08W-PM
Meeting
- Bucks Creek 1101 Phase 1,2&3 - Pre-Engineering

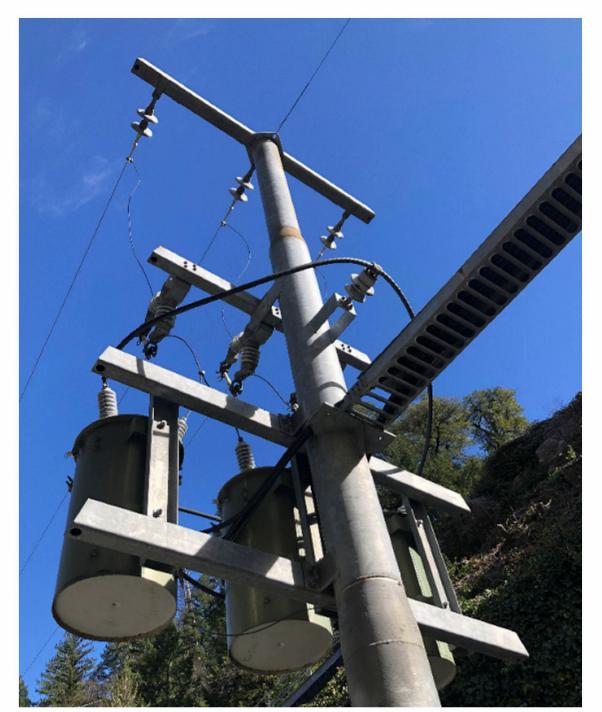
- 3. 'Underground' scope between locations 102 and 101 doesn't make sense when the following are considered:
  - a. How does this scope reduce risk?
  - b. Is 'undergrounding this small section 'constructible' when you consider the following:
    - i. Stairway, creek crossing, and proximity to sub-station
  - c. See picture

- 3. All parties had the same burning question regarding the 'river crossing';
  - a. Why couldn't we move Location 4 to the east side of CA-70 and remove Locations 5, 6, 7, and 8 of the OH-Hardening scope? This would require in increase in OH-UG scope on PM about the same distance of OH-Hardening scope begin removed from PM
  - b. Here is the basic idea in RED.....the dashed line is proposing UG:

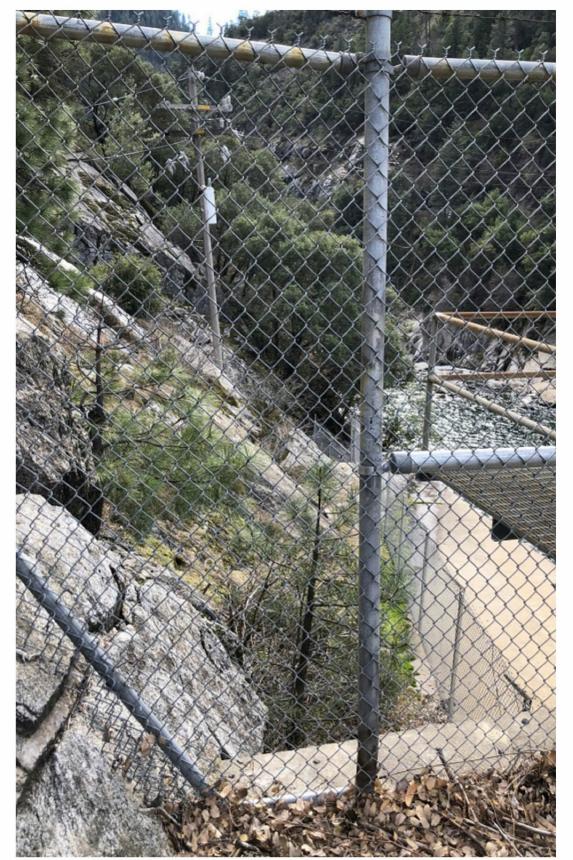
1. RR Siding Service/Tx located in picture below also has a weather station on pole and scope for replacing this Tx is another 'what if' scenario of:

- a. Does the RR need the service?
- b. If they do can we serve via a crossing at the Cresta Dam.
- c. If Cresta Dam doesn't work should we cross the river a different location?
- d. What do we do about the weather station?

- e. Here is pic:
- 2. Termination of UG scope at Cresta Dam is not clear for the following reasons:
  - a. Not constructible to 'trench' to....see pic:
